## Wisconsin Department of Transportation

**Proposal #35: 6685-03-72, WISC 2025055**  
**T Spencer, Pleasant Road**  
**E Br Yellow River Bridge B-37-0477**  
**Loc Str**  
**Marathon County**

This is Addendum No. 02, which provides for the following:

| TYPICAL SECTION &<br>QUANTITIES                                                             |                    | SHEET 2 OF 11<br>37 |

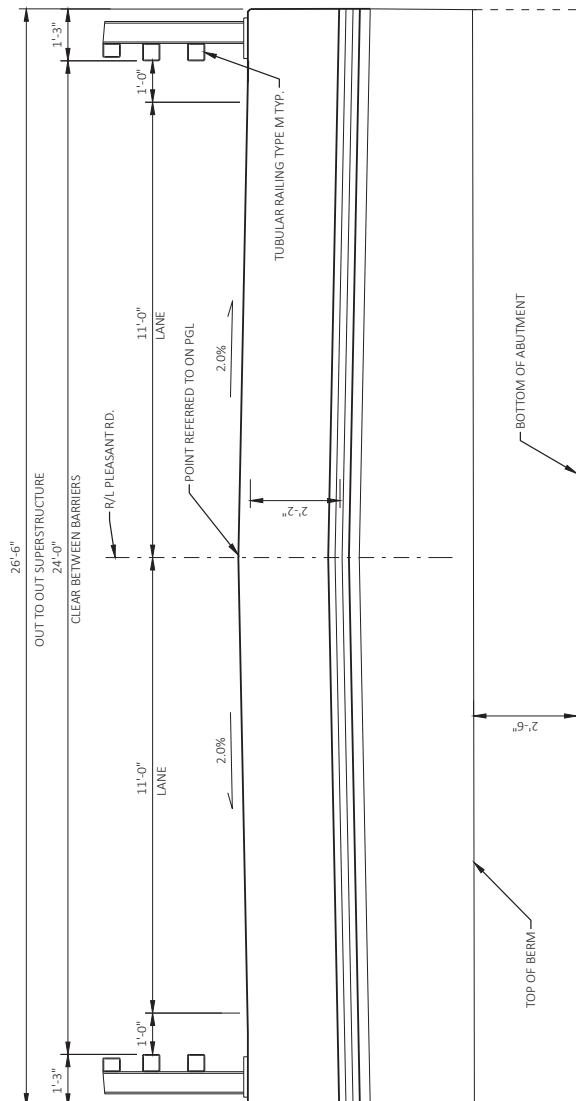
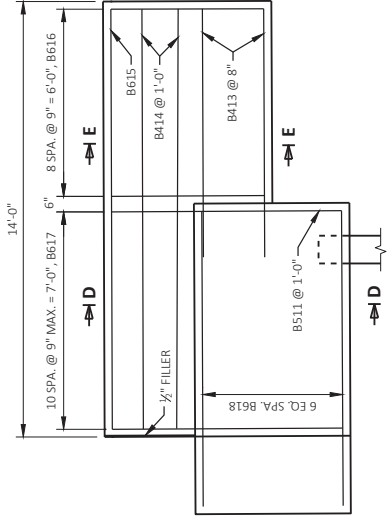
| Revised Plan Sheets |                                                          |
|---------------------|----------------------------------------------------------|
| 37, 42, 43, 45      | Revised bar steel items                                  |

|  11/8/24 | REBAR QUANTITY     | JRM                 |

| BID ITEM NO. | BID ITEMS                                                | UNIT | S ABUT. | N ABUT. | SUPER  | TOTAL                 |
|--------------|----------------------------------------------------------|------|---------|---------|--------|-----------------------|
| 505.0400     | BAR STEEL REINFORCEMENT HIS STRUCTURES                   | LB   | 1,690   | 1,690   | -      | 3,380                 |
| 505.0600     | BAR STEEL REINFORCEMENT HIS COATED STRUCTURES            | LB   | 1,400   | 1,400   | 20,240 | 23,040                |

| NORTH ABUTMENT<br>DETAILS                          |                | SHEET 7 OF 11 |

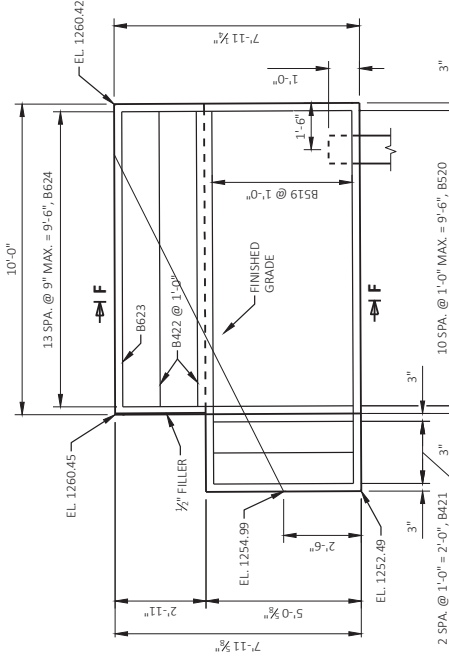
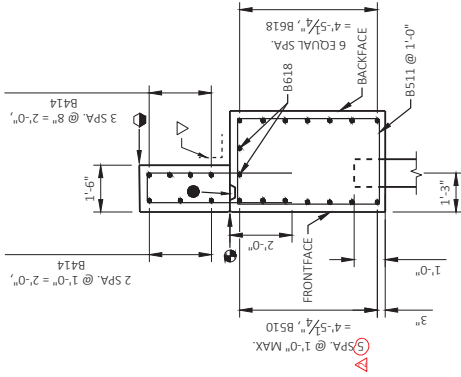
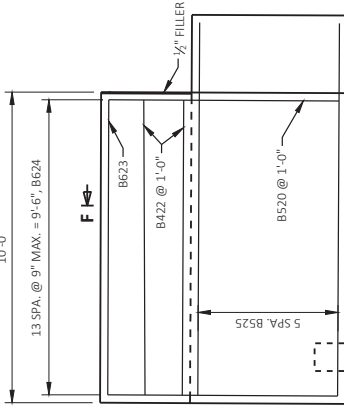
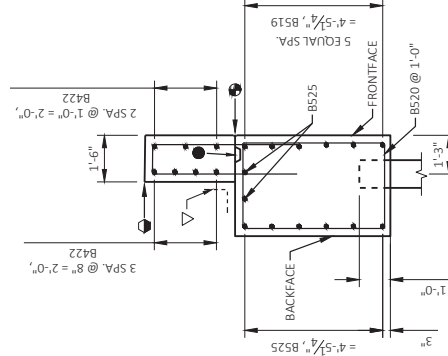
| 11/8/24                                            | REBAR QUANTITY | JRM           |

| SUPERSTRUCTURE DETAILS |          | SHEET 10 OF 11               |     |

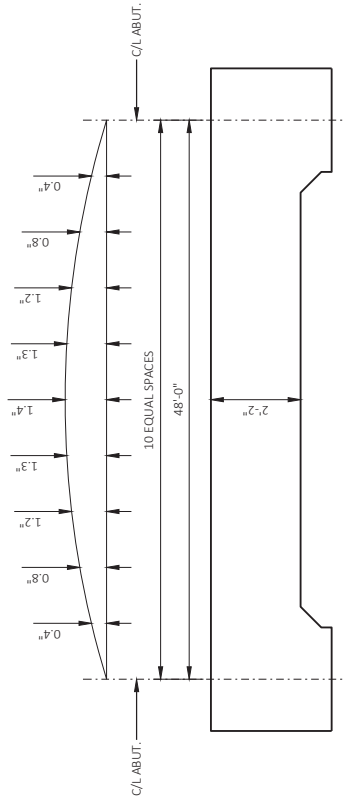
| DATE                   | 11/8/24  | REBAR QUANTITY               | JRM |
